Clause 104 Maintenance Requests #3

Overview

Technical, 802.3cg, Page 93, Table 104-7, Item 6b

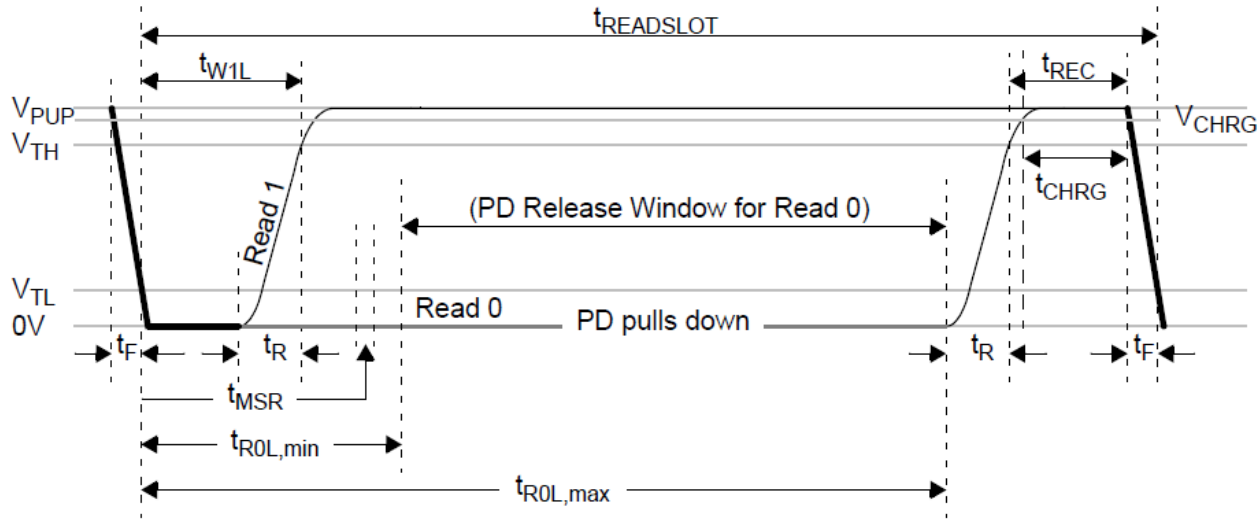
- ▶ C_{IN_CLASS} is limited to ensure that excessive rise and fall times do not interfere with SCCP
 - Other timing parameters are affected by C_{IN_CLASS}
 - t_R and t_F were generous and can already accommodate C_{IN_CLASS} of up to 0.8uF
- ▶ C_{IN_CLASS}, max is 0.4uF for Type E
- ▶ This value is unnecessarily restrictive and potentially infeasible
 - A reservoir cap is required to maintain PD operation during Reset commands

Modify Table 104-7, Item 6b

| 6b | Input capacitance during DO_CLASSIFICATION state | C _{IN_Class} | μF | — | 0.2 | A, A₁ <u>B, C, D</u> | All classes <u>Applies during t_R and t_F only.</u> |
| | | | | = | 0.4 <u>0.8</u> | <u>E</u> | |

SCCP t_{REC} Timing

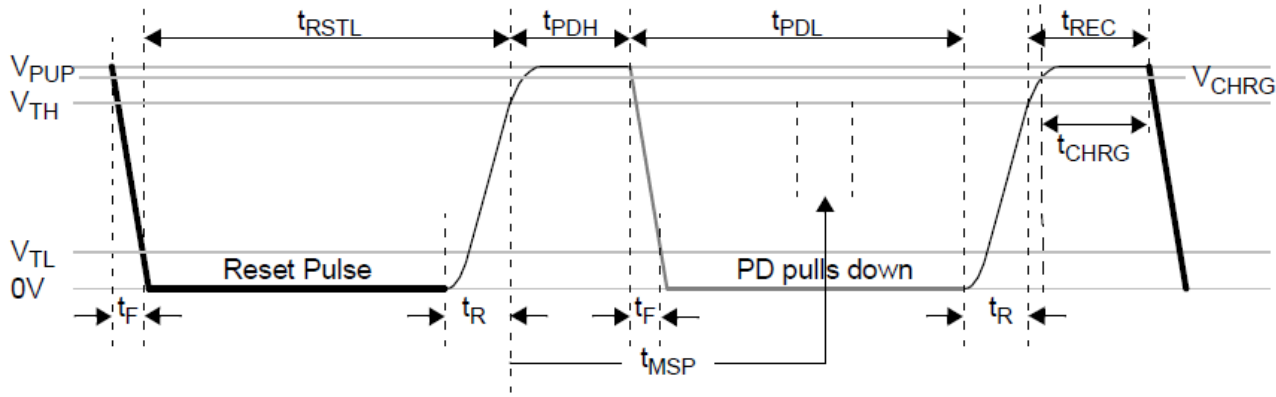
- ▶ t_{REC} should be treated like t_{CHRG}
 - t_{REC} max timing is already constrained by $t_{READ/WITESLOT}$
 - Real world slew rates between V_{TH} and V_{PUP} , rising, cannot be accommodated by existing timing relationships
 - **Propose:** Only a min should be specified, increase min to track C_{IN_CLASS} change
- ▶ t_{CHRG} introduces confusion without adding value
 - t_{CHRG} was intended to enable reservoir capacitor recharge but instead interferes by over-constraining charge
 - **Propose:** Remove as redundant to t_{REC}

SCCP Reset Command Timing

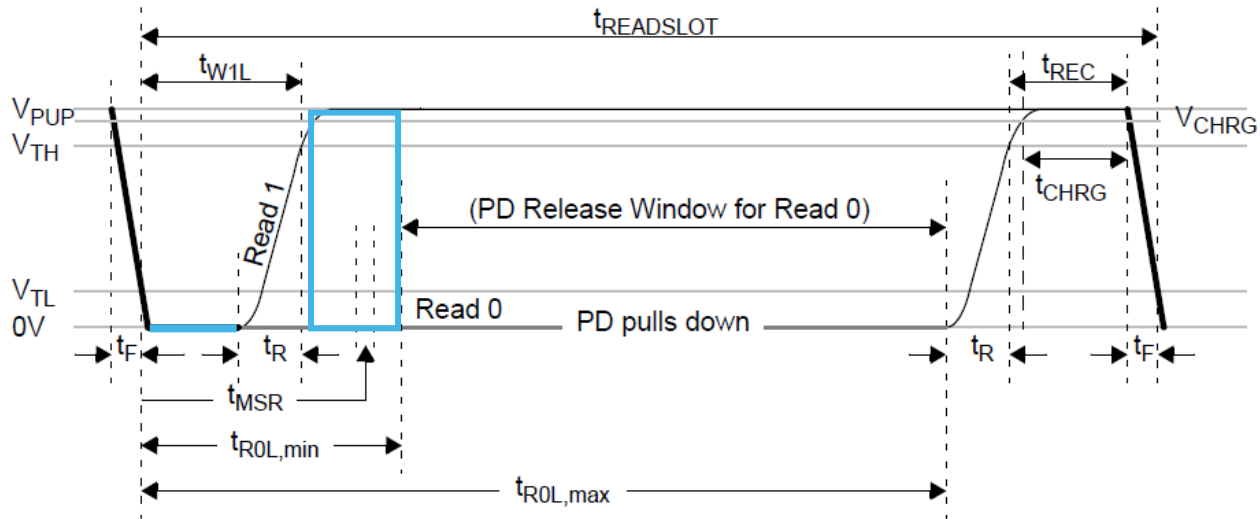
- ▶ C_{IN_CLASS} change lengthens real-world Reset component timings
- ▶ T_{PDL} was by far the tightest PD timing accuracy requirement
 - Make rationale and economically feasible by increasing to $\sim\pm 20\%$
- ▶ Incorporate t_{REC} change as proposed previously
- ▶ **Propose:** Changes as shown

SCCP t_{READSLOT} Timing

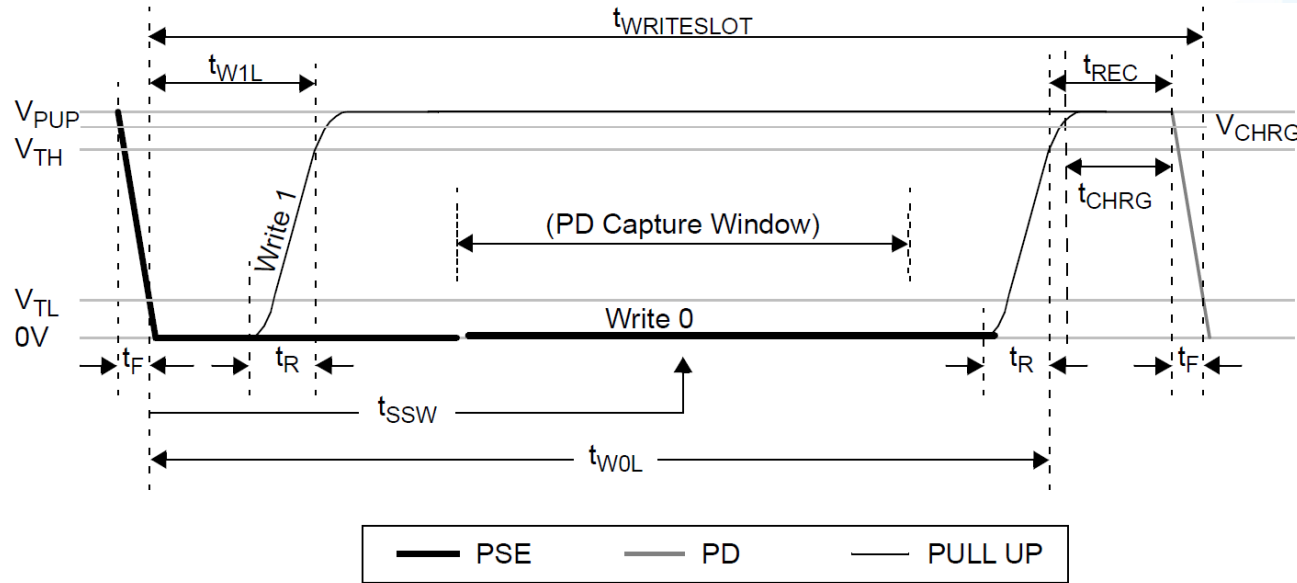
- ▶ Late changes to Read Slot component timing affected t_{READSLOT} but were not accounted correctly
 - Original $t_{\text{READSLOT,max}}$ did not correlate to sum of components
- ▶ Original calcs did not account for PSE and PD discrepancies for t_{R} and t_{F} in end-to-end systems
- ▶ Incorporate t_{REC} change as proposed previously
- ▶ **Propose:** Changes as shown

SCCP $t_{\text{WRITESLOT}}$ Timing

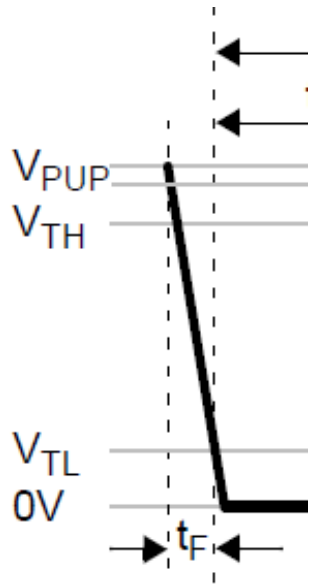
- ▶ Original calcs did not account for PSE and PD discrepancies for t_{R} and t_{F} in end-to-end systems
- ▶ $C_{\text{IN_CLASS}}$ change lengthens real-world Write Slot component timings
- ▶ Incorporate t_{REC} change as proposed previously
- ▶ **Propose:** Changes as shown

Figure 104-10—Reset command timing diagram

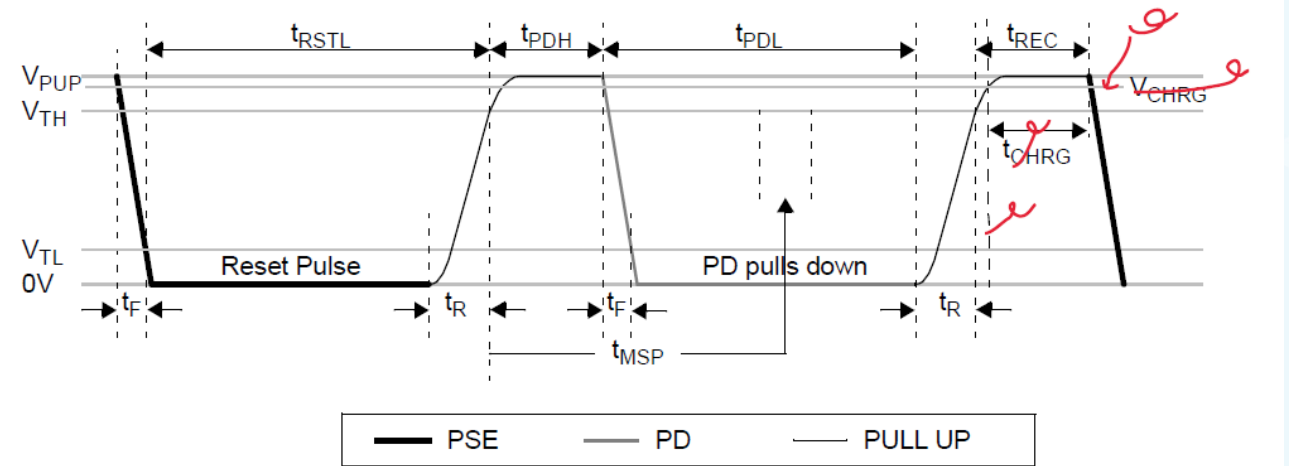
V_CHRG and t_CHRG requirements are limiting without bringing value to the standard.

Modify Figure 104-10 as shown.

Remove V_CHRG and associated voltage line.

Remove t_CHRG arrow and text.

Remove timing reference dashed line at right end of t_CHRG arrow.

Figure 104-11—Write 0/1 slot timing diagram

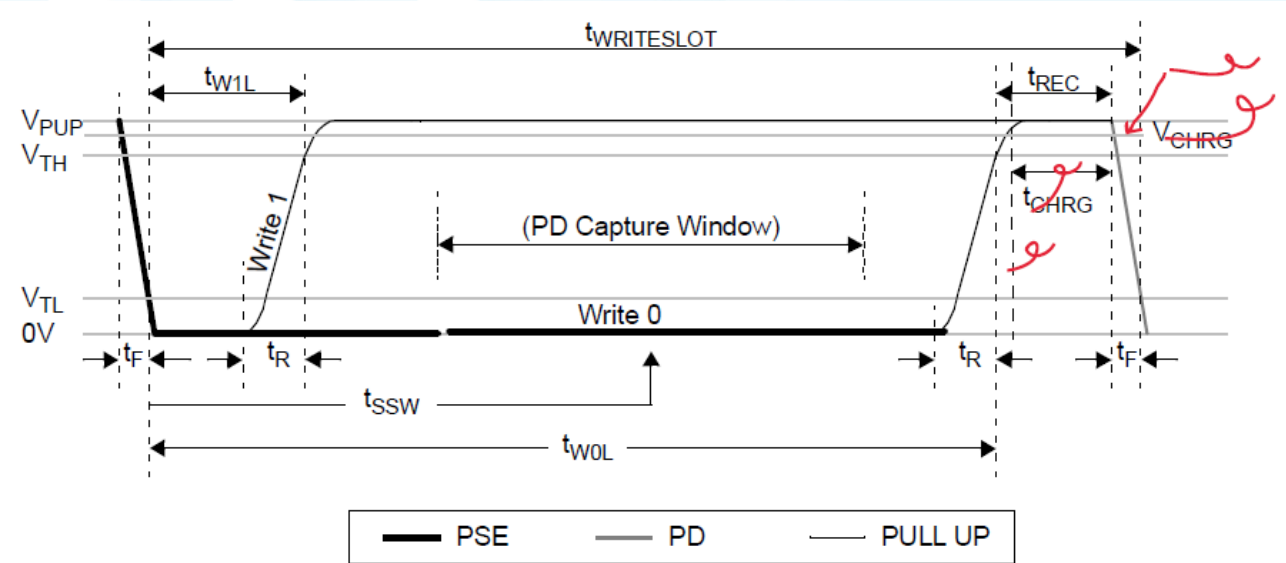
V_CHRG and t_CHRG requirements are limiting without bringing value to the standard.

Modify Figure 104-11 as shown.

Remove V_CHRG and associated voltage line.

Remove t_CHRG arrow and text.

Remove timing reference dashed line at right end of t_CHRG arrow.

Figure 104-12—Read 0/1 slot timing diagram

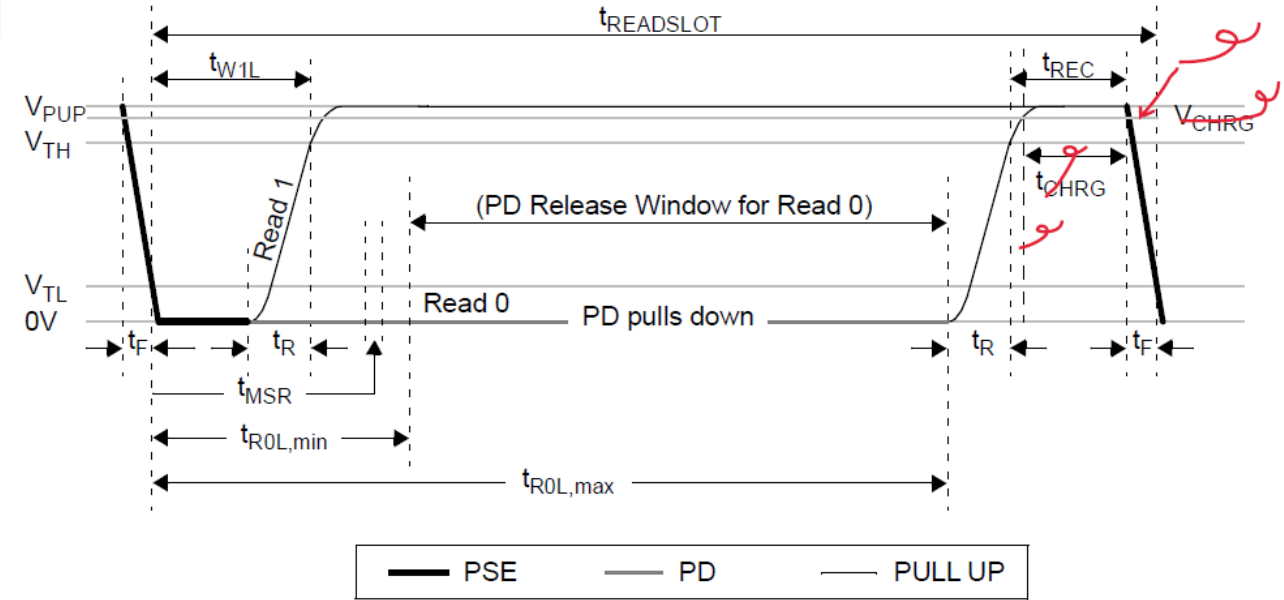
V_CHRG and t_CHRG requirements are limiting without bringing value to the standard.

Modify Figure 104-12 as shown.

Remove V_CHRG and associated voltage line.

Remove t_CHRG arrow and text.

Remove timing reference dashed line at right end of t_CHRG arrow.
